DESIGN PROFESSIONAL INSPECTION FORM

REPORT OF OBSERVATION AND EVALUATION

I OBSERVED CONSTRUCTION OF GARAGE ADDITION ON THIS DATE.

Addition of Garage

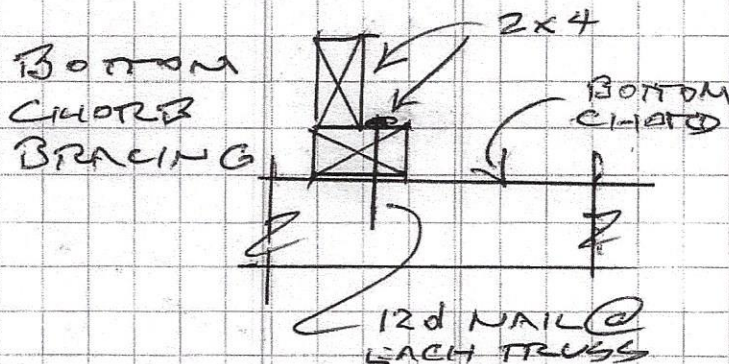
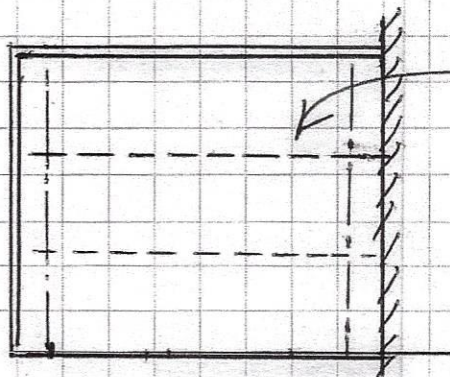
1. GABLE TRUSS BEARING ADEQUATE.
2. REMOVE/REPLACE BRICK MOUNTS AS SHOWN IN DETAIL B.
3. INSTALL DOUBLE TOP PL AND HEADER AT WINDOWS AS SHOWN IN DETAIL A.
4. ADD STRAP TO POST AS SHOWN IN DETAIL C.
5. ADD 2 LINES OF BRACING @ BOTTOM CHORD OF ROOF TRUSSES AS SHOWN BELOW
6. FOOTING PROJECTION / DEPTH ADEQUATE.
